Access Compliance Report

Public Rights-of-Way

(Curb Ramps)

Intersection ID: 5073	Main Street: FROSTMOOR_PL	Cross Street: HEDGECREST_PL	Location: SE
ADA ID: BC2C03FBC06C	Ramp Type: Perp	Initial Pass/Fail: Fail	Overall Compliance: No
Severity Score: 33.75			
Codes/Mitigation Info/Possible Solution		Field Measurements/Component Compliance

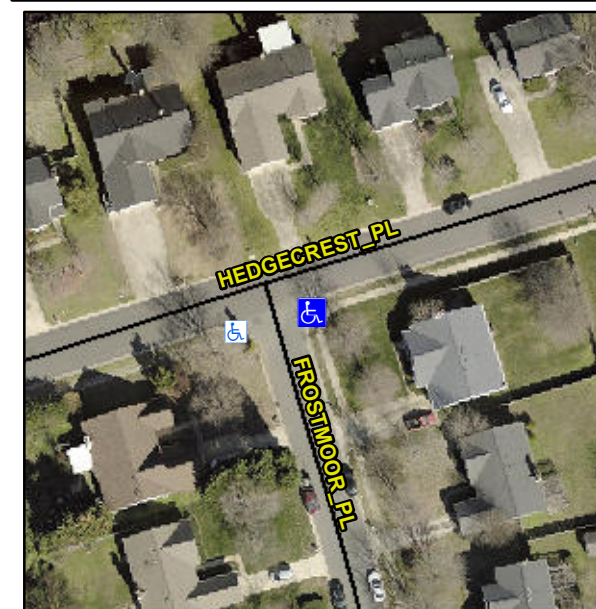
Not Found, R304.5.1, R304.2.2, R304.5.3

Compliance	Description	Data	Compliance	Description	Data
N/A	Ramp Length (in)	46.5	No	Ramp Slope (%)	9.4
No	Ramp Width (in)	44.0	No	Ramp XSlope (%)	6.6
N/A	Flare Type LT	N/A	N/A	Flare Type RT	N/A
N/A	Flare Slope LT (%)	N/A	N/A	Flare Slope RT (%)	N/A
N/A	Flare Traversable LT?	N/A	N/A	Flare Traversable RT?	N/A
N/A	Landing Length (in)	N/A	N/A	DWS Provided?	N/A
N/A	Landing Width (in)	N/A	N/A	DWS Contrast?	N/A
N/A	Landing Slope (%)	N/A	N/A	DWS Length (in)	N/A
N/A	Landing X Slope (%)	N/A	N/A	DWS Full Width?	N/A
N/A	Landing Curb? (Y/N)	N/A	N/A	DWS Offset (in)	N/A
N/A	Shared Landing?	N/A			
N/A	Gutter Ponding?	N/A	N/A	Gutter Slope (%)	N/A
N/A	Gutter Lip Ht (in)	N/A	N/A	Gutter X Slope (%)	N/A
N/A	Painted X Walk1?	No	N/A	Painted X Walk2?	N/A
	X Walk 1 Direction	To W		X Walk 2 Direction	N/A
N/A	X Walk 1 Width (in)	N/A	N/A	X Walk 2 Width (in)	N/A
	X Walk 1 Slope (%)	3.4		X Walk 2 Slope (%)	N/A
	X Walk 1 X Slope (%)	3.2		X Walk 2 X Slope (%)	N/A

Remove & Replace Entire Ramp.
